ITEM 15
MANAGER'S REPORT NO. 7
COUNCIL MEETING 90/01/29

RE: PROPOSED DEVELOPMENT "DOMINION BRIDGE" SITE BOUNDARY ROAD/LOUGHEED HIGHWAY
GILMORE WAY - REZONING REFERENCE NO. 107/88

TO: MUNICIPAL MANAGER 1990 JANUARY 24
FROM: DIRECTOR PLANNING &
BUILDING INSPECTION
SUBJECT: PROPOSED DEVELOPMENT
"DOMINION BRIDGE" SITE
BOUNDARY ROAD/LOUGHEED HIGHWAY/GILMORE WAY
REZONING REFERENCE #107/88

PRELIMINARY REVIEW
"DOMINION BRIDGE" LANDS

SKETCH # 1

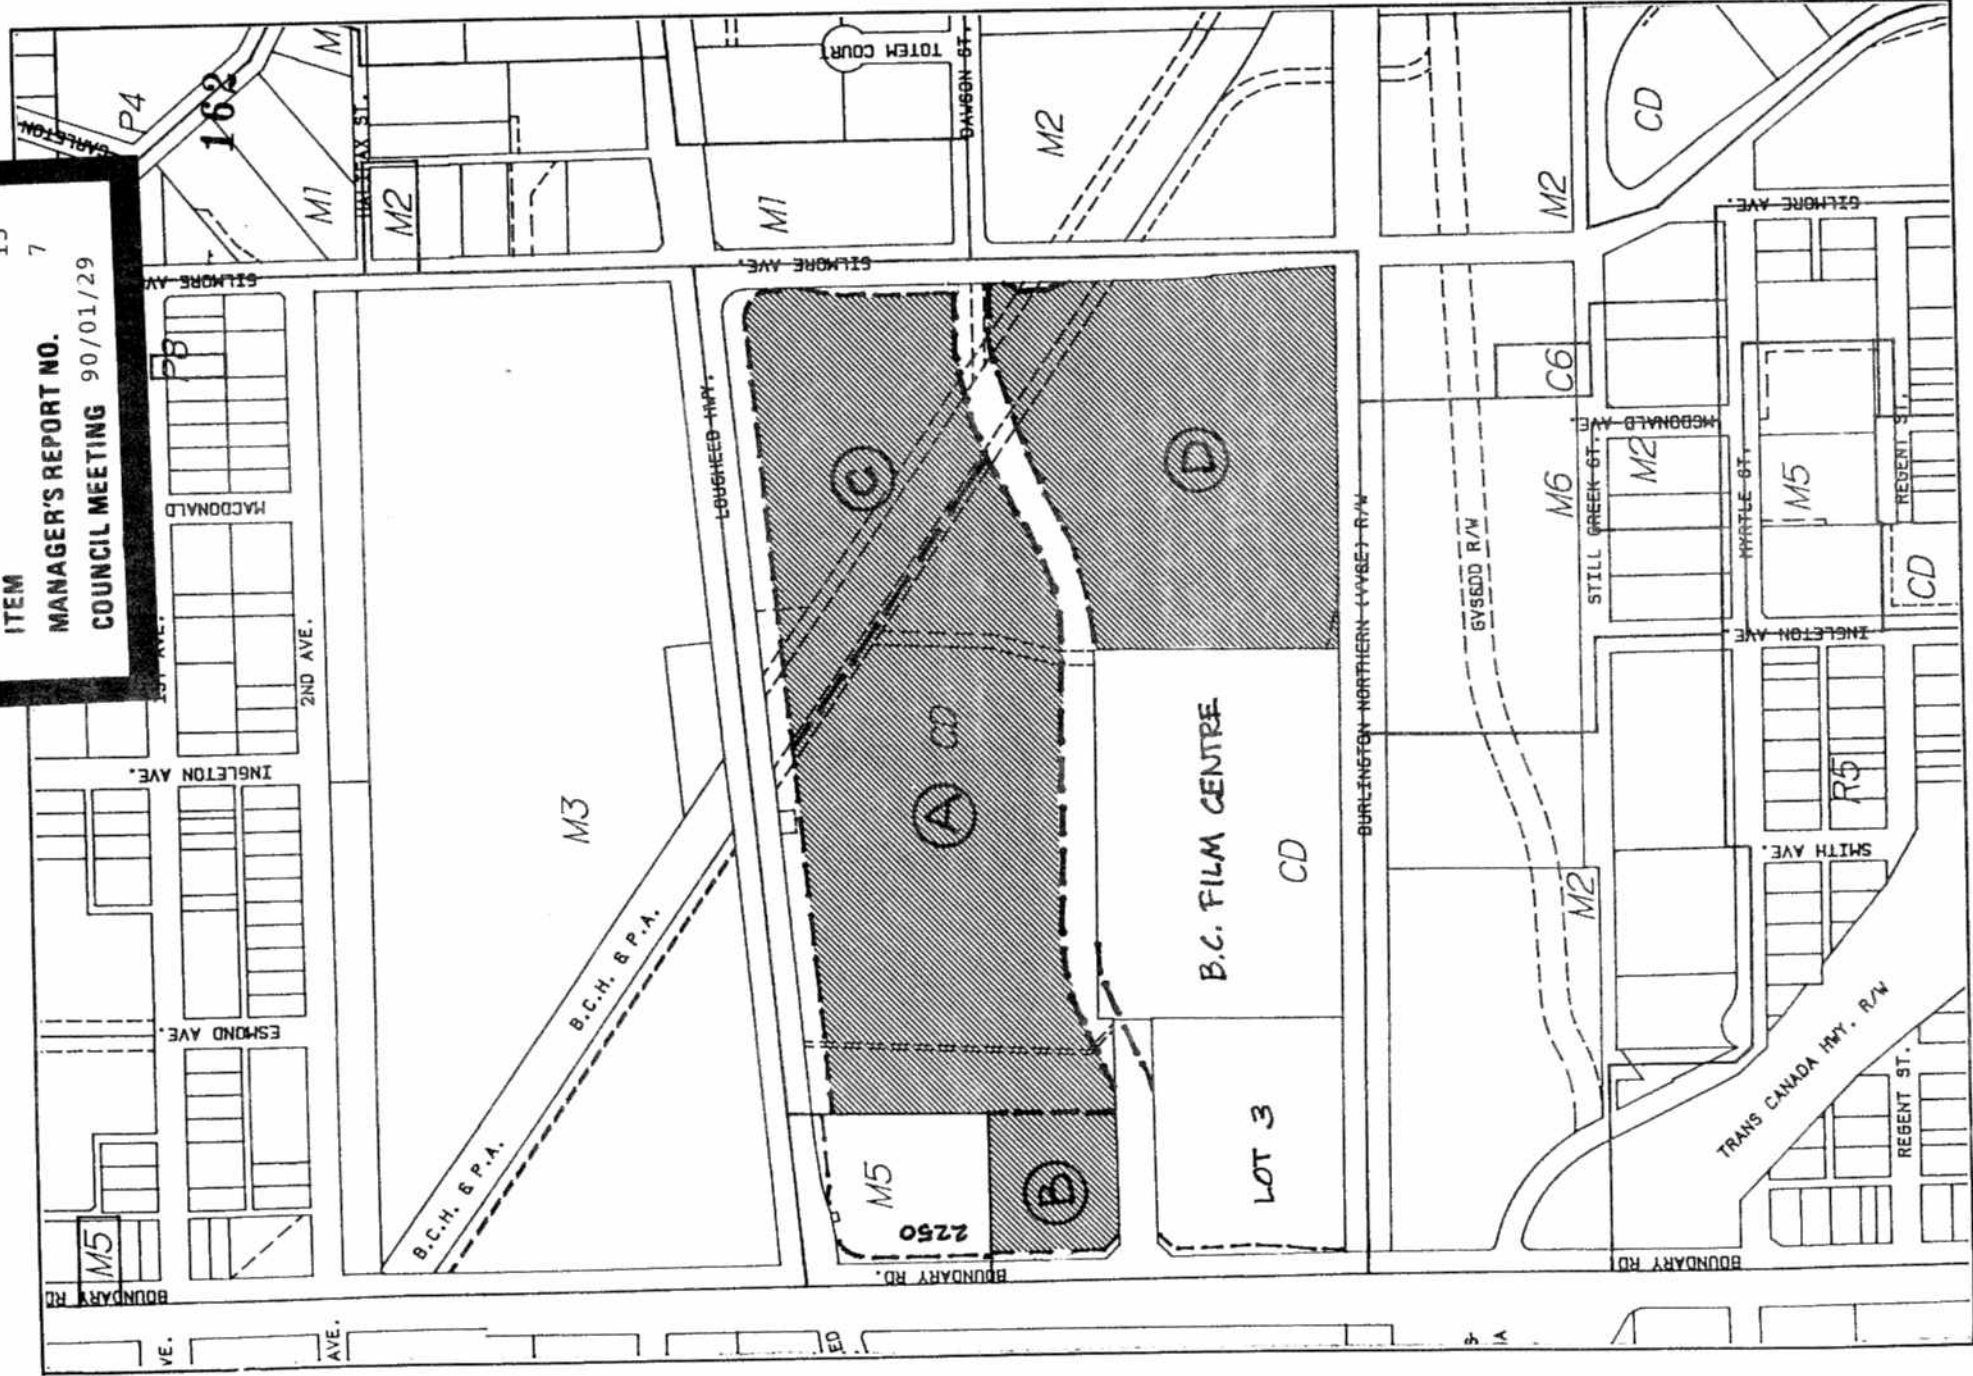
In accordance with Council direction, staff have pursued a review of the subject development proposal, including discussions with the developer and his consultants. Attached as Appendix "A" is a "Preliminary Review" of the development proposal, the contents of which have been given to the developer and been the basis for review and discussion with the developer. Appendix "A" represents an updated summary. In part, this review relates to achievement of the development objectives outlined by Mr. Hamilton in his presentation to Council. During the period of the review, the development proposal has been modified by the developer and now consists of the following components (see attached Sketch #1).

It should be noted that all the above statistics must be regarded as approximations, as they are based on limited information provided by the developer to date, who has also noted that "the layout and extent of the office, R & D and hotel may vary with the final requirements for major tenants". It should also be noted that the parking provision indicated is based on a site plan which does not meet all road dedication and landscape setback requirements.

- 7.2 The submitted plan does not meet the above-noted setback criteria along any road, and is most seriously deficient along the new Henning Drive-Dawson Street connector road (where parking and loading areas are located in front yard areas) and the Loughheed Highway.

- 8.2 Any buildings or parking/driveway areas should be kept back a minimum 30 ft. from the water's edge in order to allow the watercourse to be retained and enhanced in a natural landscaped parkway setting accommodating pedestrians on a pathway also providing G.V.S. & D.D. service access. The submitted plan does not meet this guideline.
- 8.3 The watercourse is maintained in an open condition with only the Henning Drive-Dawson Street connector road and a single pedestrian pathway crossing it.
- 8.4 The developer proposes to cross the watercourse with a box culvert. A bridge crossing is considered more desirable for environmental and aesthetic reasons.

- 9.4 A public spine road (Henning Drive-Dawson Street connector) through the site from Boundary Road to Gilmore Avenue forms an essential part of the road network required to service the proposed development and serving as an industrial collector for this area (connecting with Dawson Street) paralleling the Loughheed Highway. The need for this public spine road was addressed in conjunction with previous court proceedings related to this site. The submitted development plan incorporates an acceptable road alignment in this regard. The currently proposed location of the road, flanking the entire north boundary of the existing B. C. Film Centre is related to achievement of a large site (15.6 acres) to accommodate the proposed shopping centre (see Sketch #1 attached).

A right-turn lane on the west side of Gilmore Avenue into the Henning Drive-Dawson Street connector road is also required. The current development proposal does not reflect this required road dedication.

- 9.6 Required improvements to the Boundary Road and Lougheed Highway intersection to accommodate future projected traffic, including that generated by the proposed development, requires dedications from the corner site (2250 Boundary Road) which is not owned by the developer. Minor dedications in Vancouver and north of the Lougheed Highway are also required. Dedications from the subject site (proposed hotel site) along Boundary Road are also required in this regard and are not fully shown in the submitted site plan.

SKETCH #2

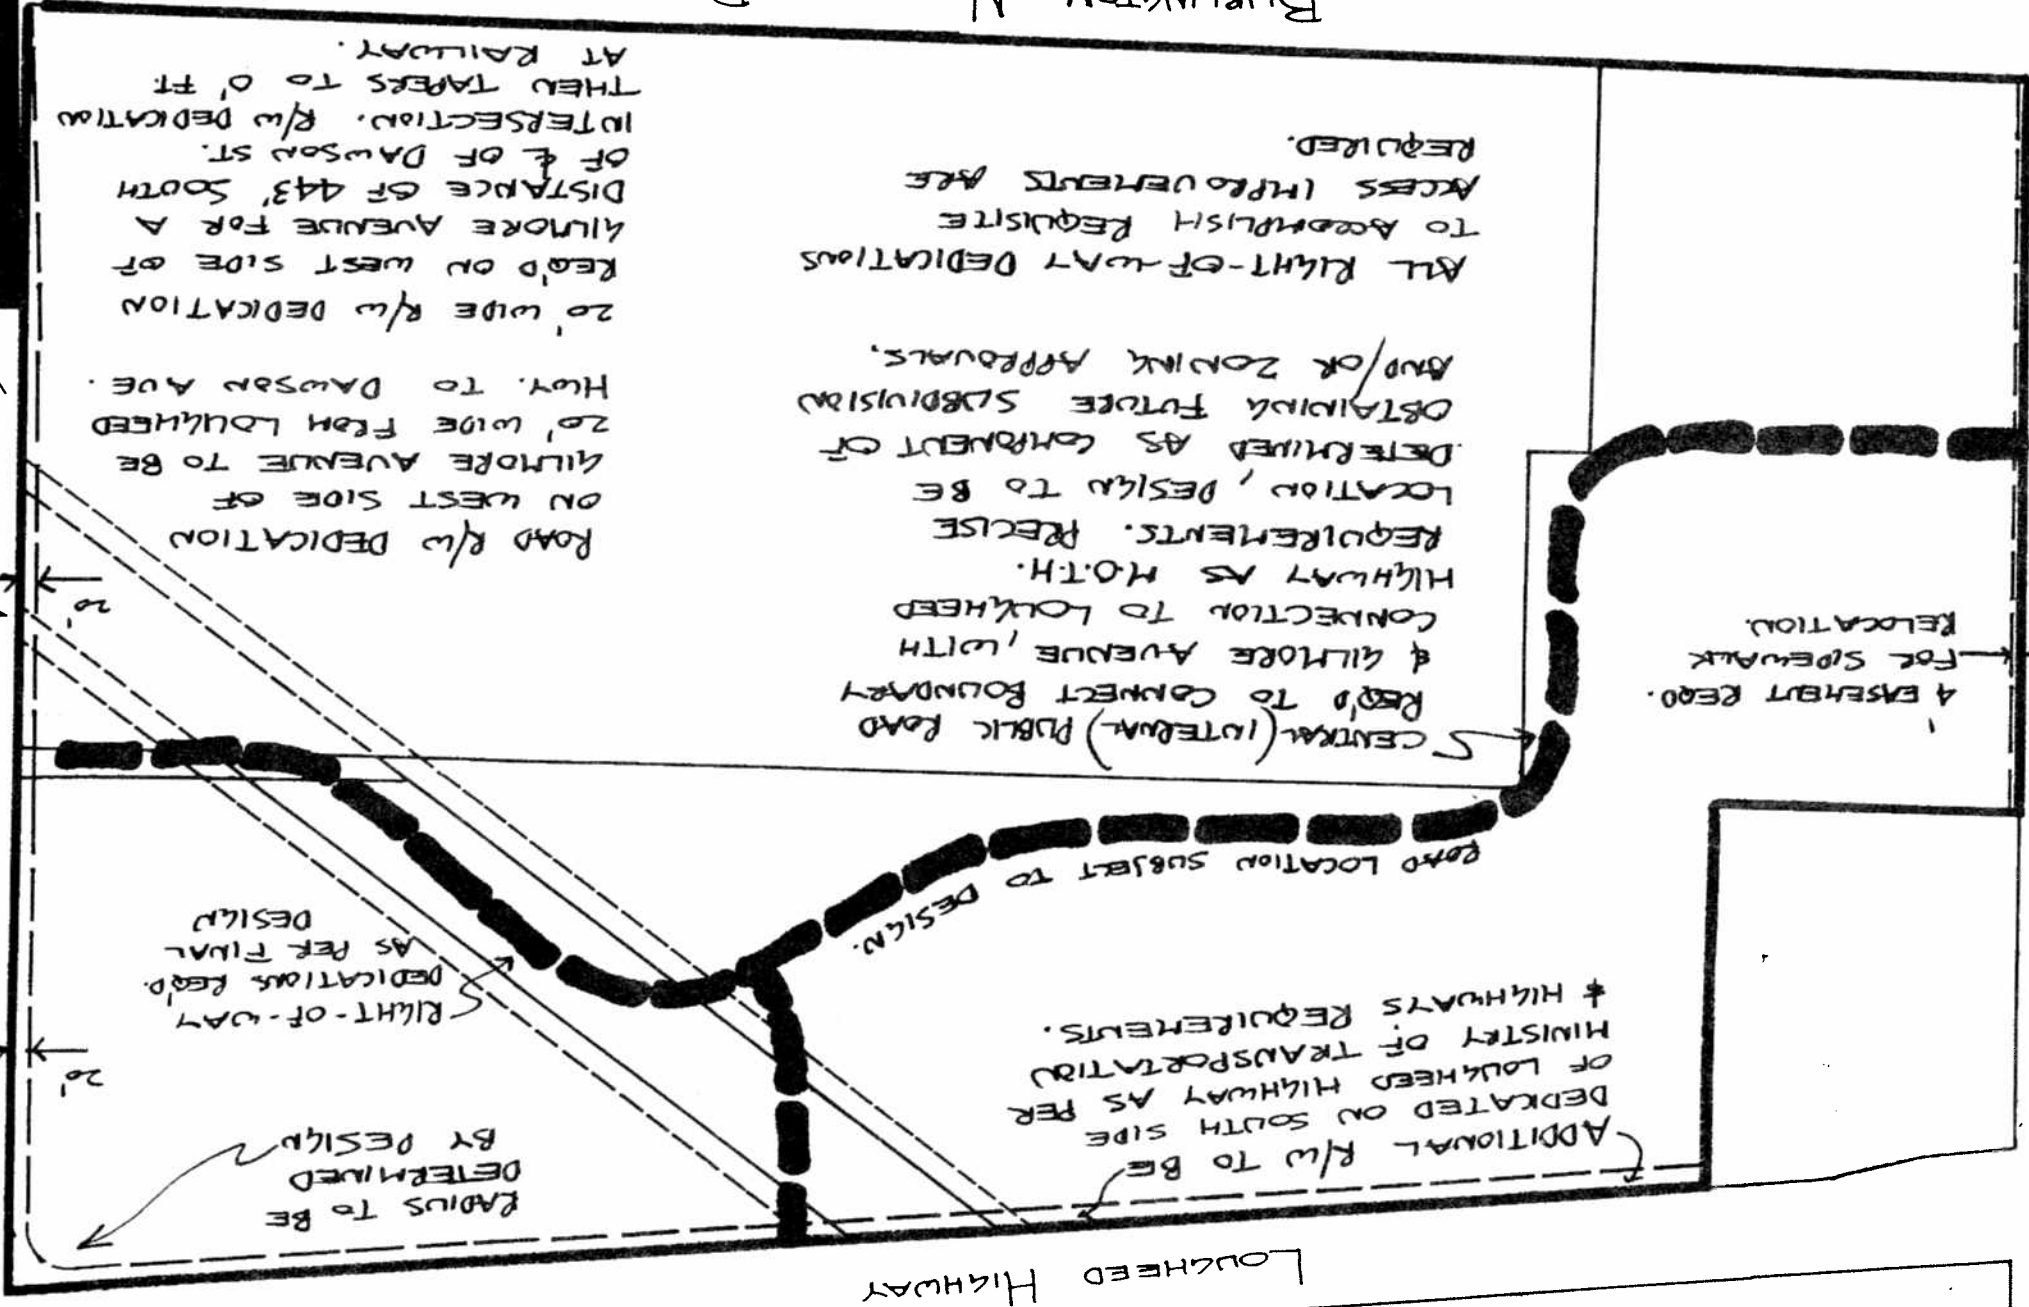
If the agreement of the B.C. Film Centre to the currently proposed Henning Drive-Dawson Street connector alignment cannot be achieved, it will be necessary to determine a suitable alternative alignment that will still achieve this important public road connection through the site. For example, Sketch #2 attached indicates a general alignment previously discussed with the applicant in 1987. The same general alignment was also shown in a sketch plan previously prepared by the applicant.
